Public Meeting Summary And Responses to Comments

Oklahoma Department of Transportation

SH-20 Keetonville Hill
From 209th E. Avenue to Franklin Road
Rogers County, JP 27031(04)

November 19, 2015

Figure 2: Proposed Curb and Gutter Section for the Remainder of SH-20 (As Shown at the Public Meeting)

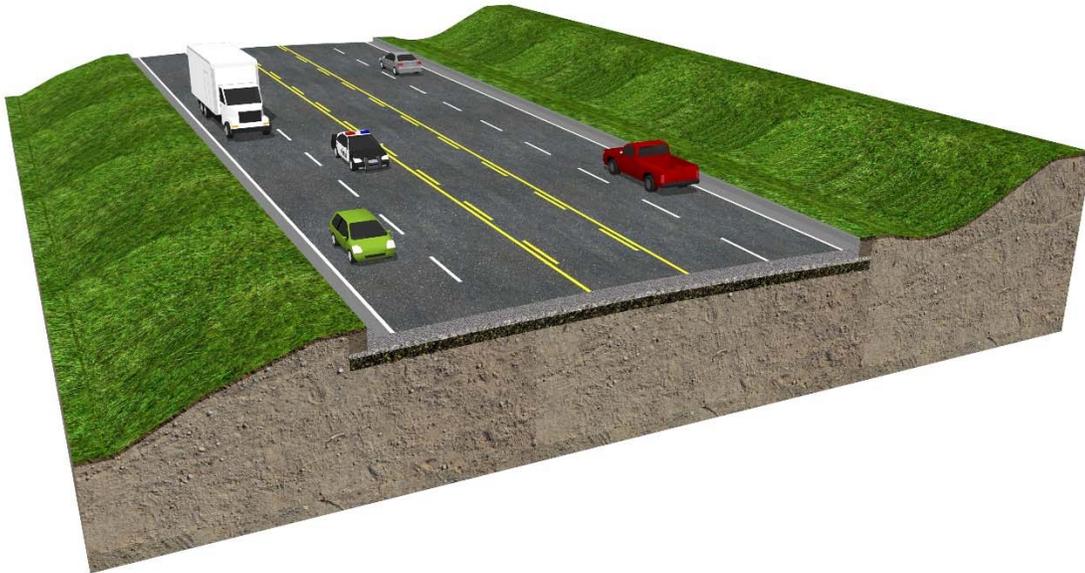
<i>Comment</i>	<i># of Comments</i>
Don't like curb & gutter section/speed limits	14
Needs to be a usable shoulder to pull off in case of breakdown or accident.	4
Curbs prevent drainage and increase risk of flooding/hydroplaning.	3
ODOT did not explain reasoning for curbs and lower speed limit. Proposed design does not match well with travel needs on this roadway.	2
Traffic travels at least at existing speed limit (55 mph). A higher speed is appropriate.	2
Traffic traveling at high speeds are at risk to hit the curbs and lose control.	1
I hate the curbs.	1
Want 5-lane with shoulders for safety and to accommodate traffic.	1
The new alignment will destroy our peace/quality of life	13
Highway will bring increased noise. What is the plan to address noise?	6
I bought my property because it is peaceful – that will be ruined.	4
Highway will ruin visual setting. What is the plan to address visual impacts?	1
Please consider people's quality of life as well as muskies and beetles.	1

The open section will transition back to the curb and gutter section near NS-410 Road, with the exact location to be determined during final design. The remainder of the corridor will retain the curb and gutter section as presented at the Public Meeting:

The roadway will be posted at 45 mph when it is opened to traffic. ODOT may conduct a speed study after construction if it is determined that actual speeds vary greatly from the posted speed limit and make an adjustment if warranted.

Figure 3: Proposed Laurel Street Connection and Westbound Access to 106th Street

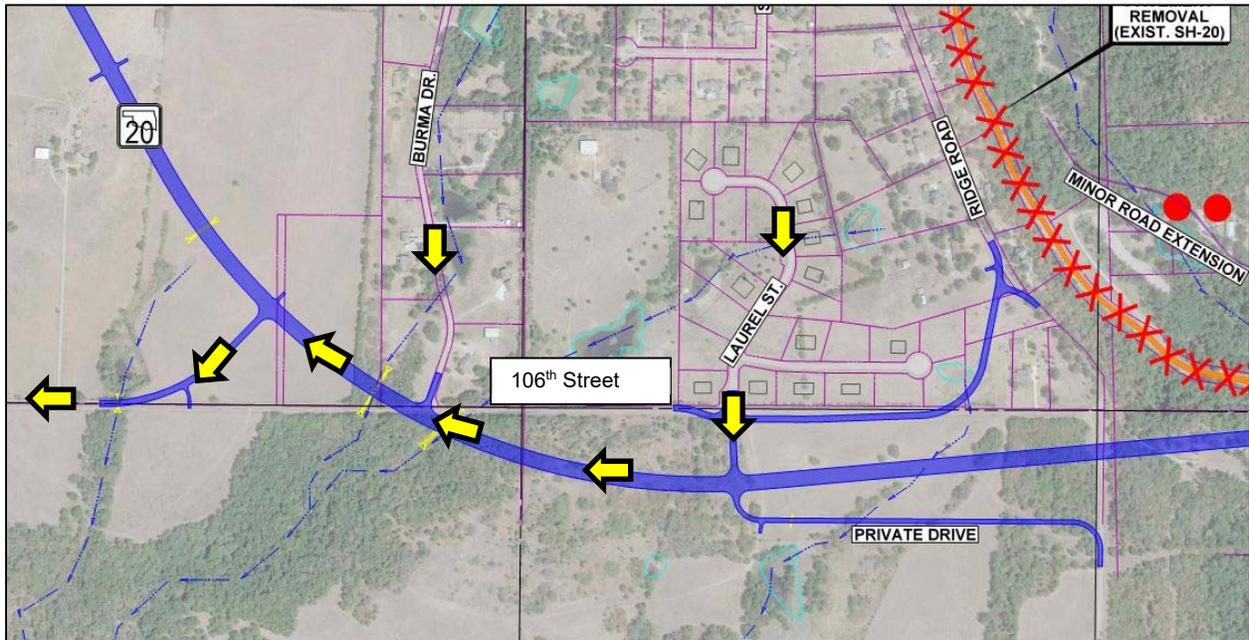
My noise tolerance is well below federal threshold of 67 dBA. Request sound barriers for my neighborhood (Laurel St.)	1
Concerns about access/design at Keetonville Ridge (Burma Road)	13
Concern that residents currently use 106 th Street (EW-49) to travel west to US-169. With the current plan, 106 th Street would be closed west of Burma Road and residents would be required to travel on SH-20 west for approximately ½ mile before turning left to access 106 th Street. Requires merging over a short distance and appears dangerous.	3
Propose a tunnel for 106 th Street under the new SH-20 to allow it to remain open. The plan shows "fill" in this area so maybe this would not be too costly.	3
Leave the existing SH-20/Ridge Road intersection. No need to destroy entrance to our neighborhood or additional pastures for a redundant road.	2
Move the alignment further south into Garth Brooks property. Is there preference being given to Garth Brooks?	2

I live on Burma Drive. How will we enter and leave our street? Will we be able to get on 106 th Ave. westbound without getting on the highway?	1

Access to 106th Street Westbound: During the initial development of alternatives, a grade-separated crossing for 106th Street at SH-20 (overpass) was considered. However, the cost of this structure would be significant and is not warranted by the low traffic volumes using 106th Street. The current design provides for an offset intersection configuration. The intersections would be to SH-20 from Burma Road, Laurel Street, and 106th Street. Traffic desiring to head westbound on 106th Street would travel along SH-20 for a distance, then turn left from the center turn-lane on SH-20 at the new 106th Street intersection (Figure 3). This “offset” intersection was considered safer for vehicles traveling westbound versus a standard crossing intersection where vehicles would have to cross 5 lanes at once to continue on 106th Street. During final design, the distance between the offset intersections will be determined and spaced appropriately to allow for traffic to safely merge from the westbound SH-20 lanes into the center turn lane. The new intersection will be stop-controlled on the approaches from 106th Street, Burma Drive and Laurel Street with SH-20 traffic remaining free-flow. Stop signs will be used on the side roads, there will not be a signal at these locations.
